Legistar I.D. #21563
640 North Henry Street
Conditional Use Alteration Request

Requested Action: Approval of a major alteration to an existing conditional use for additions and interior reconfiguration of an existing lodging house into a multifamily apartment building on a waterfront parcel in the R6 (General Residence) District.

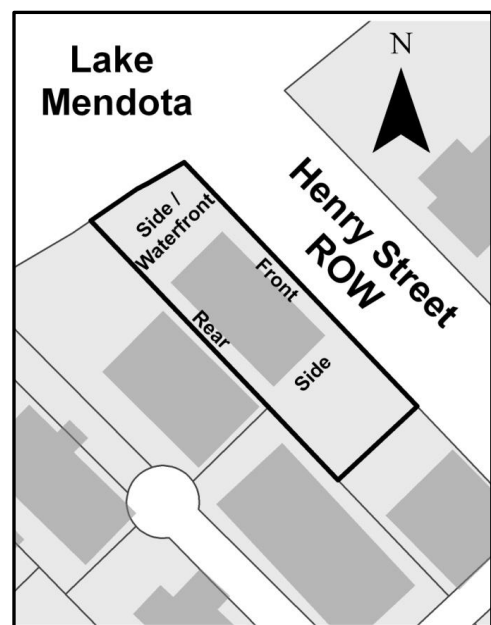
For reference, it is worth noting that the yards for this unique lot are rigidly defined by its frontage on North Henry Street. As shown to the right, the east side of the property along the North Henry Street right-of-way is officially the front yard, even while it appears as though it would be a side yard due to the lot dimensions and orientation of the building. Because of the yard requirements in Downtown Design Zone 2, the yard definition essentially prohibits a property owner from seeking PUD Zoning for this lot, since the yard requirements would be impossible to meet. With a full understanding of this limitation, the applicant is seeking a conditional use in the R6 District, which also necessitated review and approval by the Zoning Board of Appeals for variances.
